MOBILE SOUTH BUSINESS PARK SUBDIVISION,
UNIT TWO, PHASE ONE,
RESUBDIVISION OF LOTS 5 & 6 AND ADDITION TO

APPLICATION NUMBER 7 DATE June 1, 2006

REQUEST Subdivision

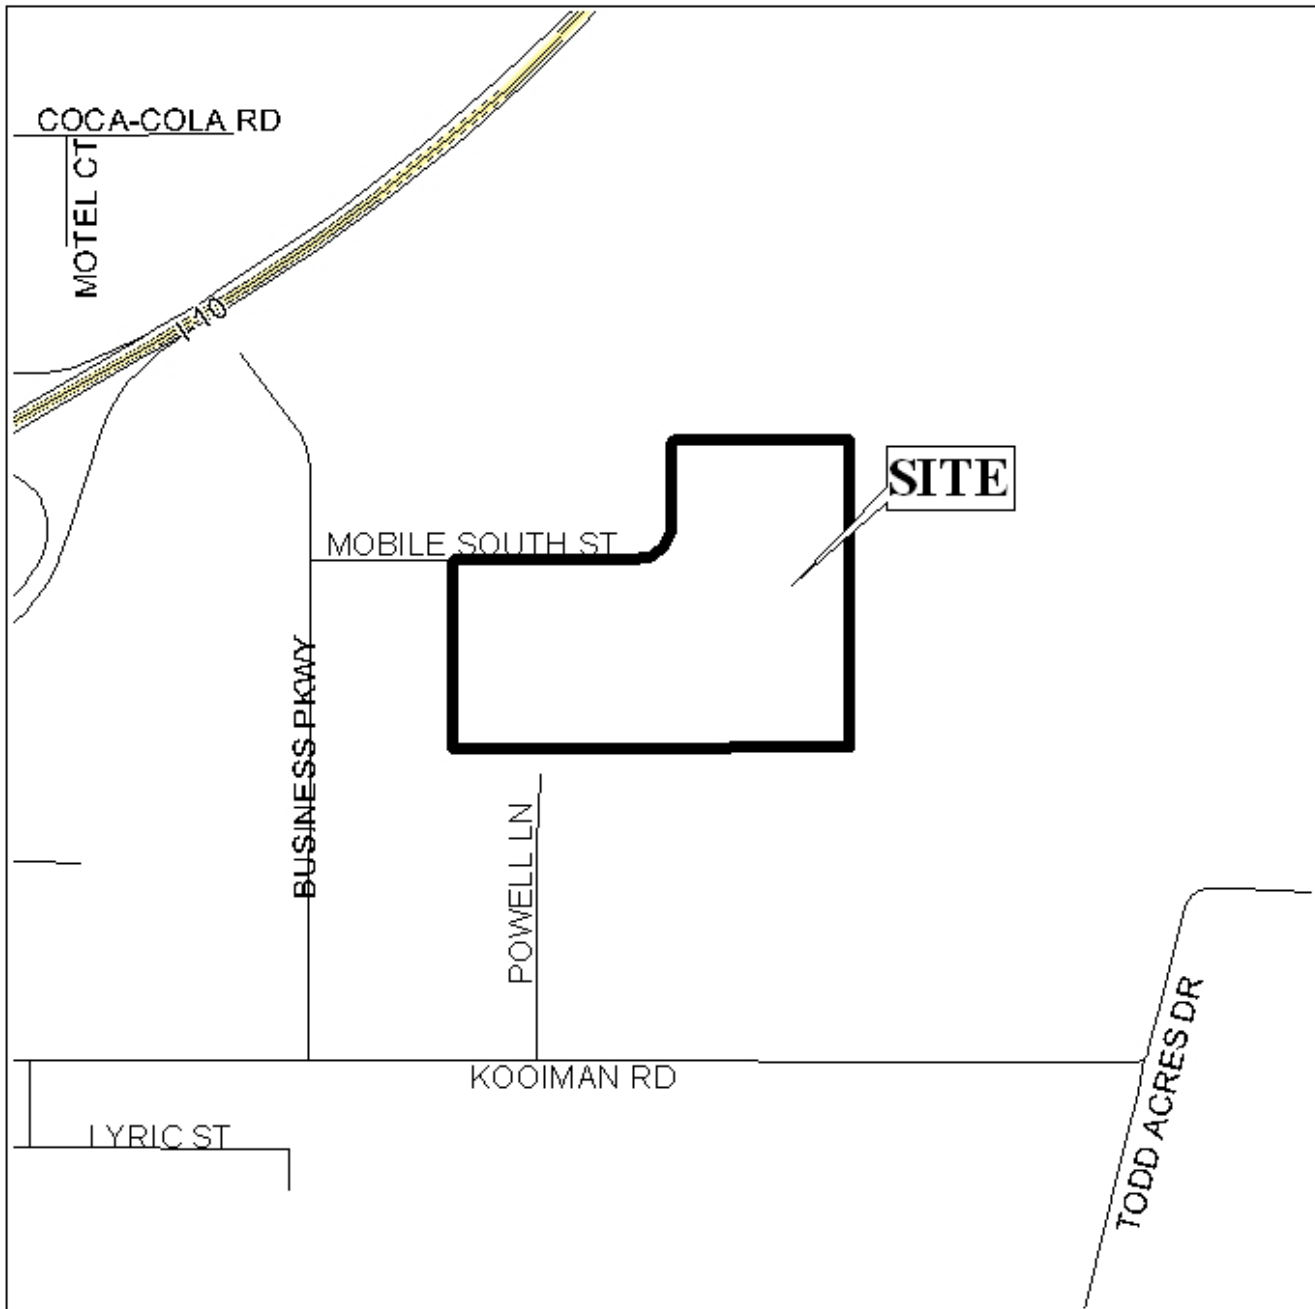
The purpose of the application is to create two lots of record from two existing lots and a third metes and bounds parcel. It is not clear that this third parcel includes the entire parent parcel, so the applicant should either include the remainder of the parent parcel, to the North, or provide documentation establishing the parcel in its present configuration prior to 1984.

The site fronts Mobile South Street, which has a 60-foot right-of-way. The plat incorrectly shows Mobile South Street extending northward along the West side of proposed Lot 2; in fact, both the street and the right-of-way terminate exactly at the edge of proposed Lot 1.

The plat shows proposed Lot 1 with ample frontage along Mobile South Street. Proposed Lot 2, however, would not have access to any constructed and dedicated public street. While this is the existing case for the metes and bounds parcel, this problem should be remedied in the subdivision process. While continuation of the street was originally approved, that approval has long since expired, and the project has not been pursued. Since the land at the terminus of the road is private property, there is no assurance that a street will ever be constructed there. Furthermore, that private property, though in the shape and size of a street, is not part of the subdivision application. It cannot be assumed that Mobile South Street will be constructed and dedicated as originally planned. Therefore, the plat should be revised to show Lot 2 as having a minimum of 25 feet of frontage on Mobile South Street, where it is publicly maintained.

As a means of access management, Lot 1 should be limited to three curb cuts, and Lot 2 limited to a single curb cut, with size, location, and design subject to County Engineering approval.

The shape of proposed Lot 2 is also quite irregular, with a long rectangle turning South from the main block. However, there are several oddly shaped parcels in the area, including quite a few long and narrow ones that appear to be reserved for future streets. This configuration does not seem to present any problems, and may be appropriate given the presence of the wetlands. Nevertheless, due to the shape and limited street frontage, no future resubdivision of Lot 2 should be considered until additional street frontage is available.

Due to the modifications required for the final plat, this application is recommended for Holdover to the July 6th meeting, with all revised materials due by June 12th. Should additional parcels need to be included, additional lot fees, mailing fees, and mailing labels will be required.
